Date: 17 May 2021

1J710, 1J711, 1J720, 1J721, 1J910, 1J911, 1J920, 1J921

Description of Change

Reference Photo | teal color cap next to new green color cap.

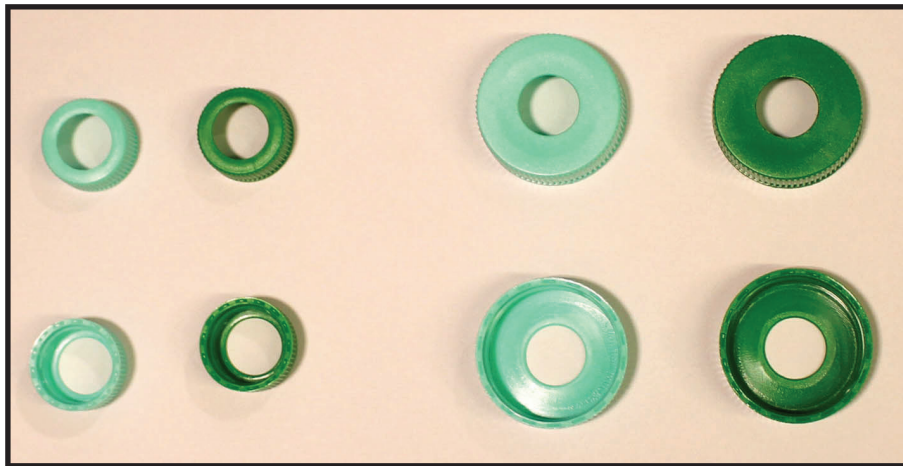
Cap color change from teal to green.

Availability and lead time improvement with no change to the materials, design, quality, performance, or manufacturing process.
